L-2002-030
10 CFR 50.90

Re: Turkey Point Units 3 and 4
Docket Nos. 50-250 and 50-251
Proposed License Amendments
Surveillance Testing 4.1.1.2.g.7 Change for Performing
The 24-Hour Emergency Diesel Generator Functional Testing
During POWER OPERATION
Response to Request for Additional Information

FIGURE 1
TURKEY POINT SIMPLIFIED ONE LINE DIAGRAM

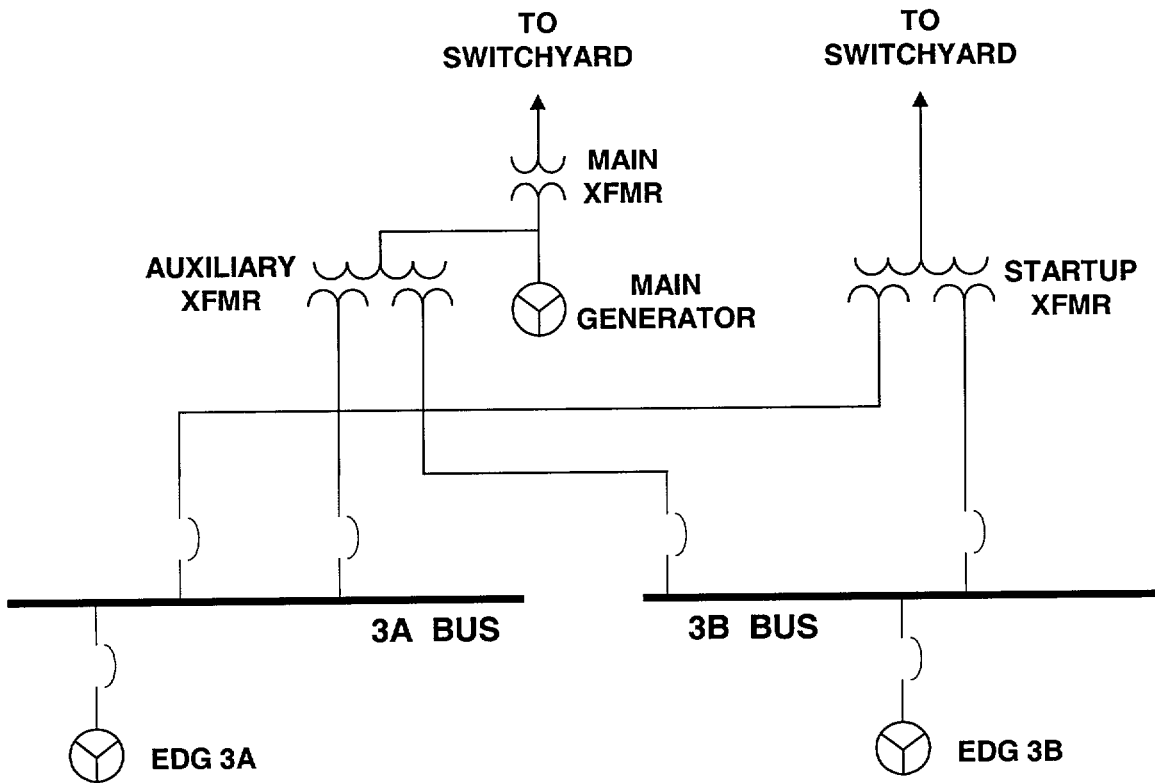
NRC Question #1: Please describe the various events that can cause loss-of-offsite power (LOOP) while the emergency diesel generator (EDG) is being tested and paralleled to offsite power. In addition, please provide a sequence of events, including timing, assuming that the EDG protective features actuates in response to a LOOP.

FPL Response #1: A simplified one-line diagram of the safety related 4 kV buses is provided below as Figure 1. In order for the bus to experience a LOOP, both the auxiliary and startup transformer breakers must be open. During unit operation, power to the safety-related buses is supplied by the auxiliary transformer. Therefore, the plant response while the EDG is being tested and paralleled to offsite power will be addressed based on the auxiliary transformer breaker being closed initially. Opening of the auxiliary transformer breaker would be the result of one the following:

1. Safety injection
2. Main generator/main transformer lockout
3. Overcurrent/bus fault
4. Spurious/inadvertent operation

The opening of the auxiliary transformer breaker in response to a safety injection signal will generate a fast bus transfer to the startup transformer. The safety injection signal also opens the breaker for the EDG being tested. Should the fast bus transfer fail, the bus would experience a LOOP. The LOOP would be sensed by loss of voltage relays and all load breakers on the associated bus would then be opened by the emergency bus load sequencer. This would be followed by reclosing of the EDG breaker and loading of accident and safe shutdown loads by the emergency bus load sequencer.

The main generator and main transformer lockout relays are actuated by numerous events as listed in the original Proposed License Amendment submittal. A grid-generated LOOP would likely result in actuation of one or both of these lockout relays. Actuation of these lockout relays will generate a fast bus transfer to the startup transformer. The main generator and main transformer lockout relays also open the breaker for the EDG being tested. If the fast bus transfer fails or if offsite power is not available from the switchyard, the bus would experience a LOOP. The LOOP would be sensed by loss of voltage relays and all load breakers on the associated bus would then be opened by the emergency bus load sequencer. This would be followed by reclosing of the EDG breaker and loading of safe shutdown loads by the emergency bus load sequencer.

An overcurrent trip of the auxiliary transformer breaker would be the result of a bus fault based on electrical fault coordination with the bus load breakers. Such an overcurrent trip would result in a bus lockout. The bus lockout trips the breaker for the EDG being tested in order to prevent potential damage to the EDG. No fast bus transfer will take place and the bus will remain de-energized until the cause of the bus fault is identified and corrected.

The spurious or inadvertent opening of the auxiliary transformer breaker would not result in a fast bus transfer or tripping of the EDG breaker. The EDG being tested would attempt to provide power to all connected bus loads and be subject to an overload condition. This would likely result in a relay race between the bus undervoltage protection and the EDG protective trips. Based on the proposed assumption that an EDG protective feature actuates first, the following sequence of events will occur.
